Diversified Metal Fabricators Service Bulletin SB 2045

Title	RW-1013 Railwheel Bearing Hardware & Adjustment
Document No.	2045
Issue Date	7/22/05 (WAK)
Units Affected	All units with RW-1013 railgear – Supercedes SB-2042
Purpose	<ul style="list-style-type: none">• To call attention to a service issue with the bearing hardware used in RW-1013 railwheels.• To provide information and guidance to those involved in service and inspections.

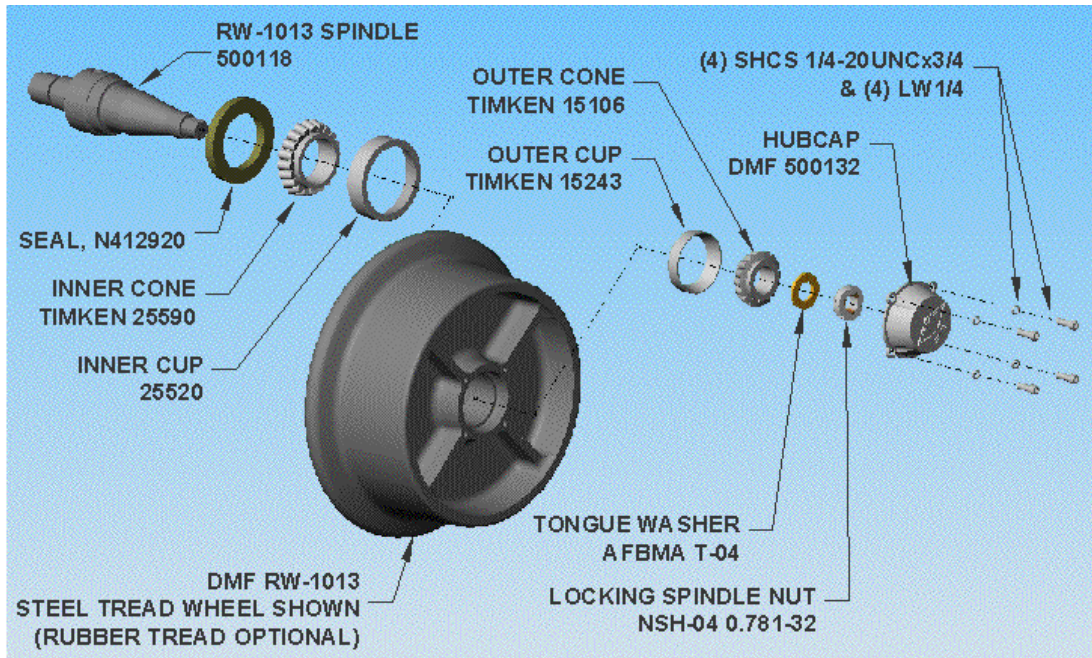
There have been cases of RW-1013 railwheels becoming loose or coming off RW-1013 equipped vehicles. To address this, the revised spindle nut includes (3) brass shoes engaged by set screws to prevent these problems. The tab washer is no longer used, the tongue washer is still used. This Service Bulletin supercedes SB-2042.

The previous nut (N-04) has four flats and may have a brass tipped set screw. The new spindle nut (NSH-04) has three flats, three set screws and three brass shoes.

ALL RW-1013 UNITS MUST HAVE THE SPINDLE NUTS REPLACED WITH THE REVISED NUT.

Exploded Assembly: RW-1013 Rail Wheel

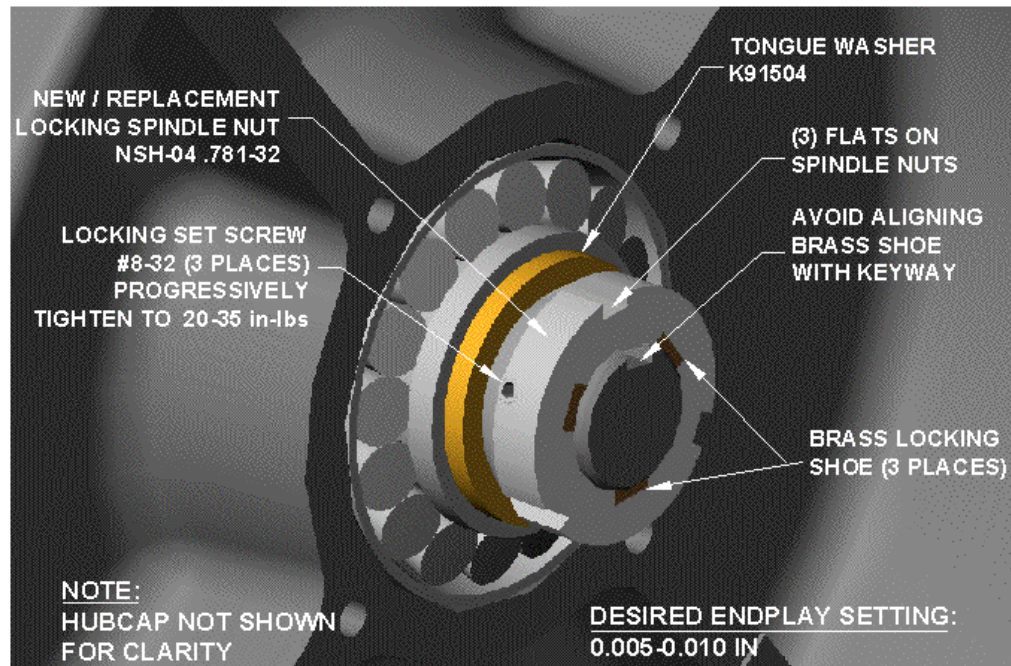
1. Assemble components as shown in attached assembly drawing.
2. Tighten spindle nut to approximately 25-50 ft-lbs
3. Rotate wheel one full turn in each direction
4. Loosen spindle nut
5. Tighten spindle nut by hand while turning wheel until snug.
6. Back off spindle nut ¼ turn and ensure that the brass shoes are clear of the keyway. (1/4 turn should give the recommended 0.005" to 0.010" of endplay)
7. Tighten set screws progressively to 20-35 in-lbs.
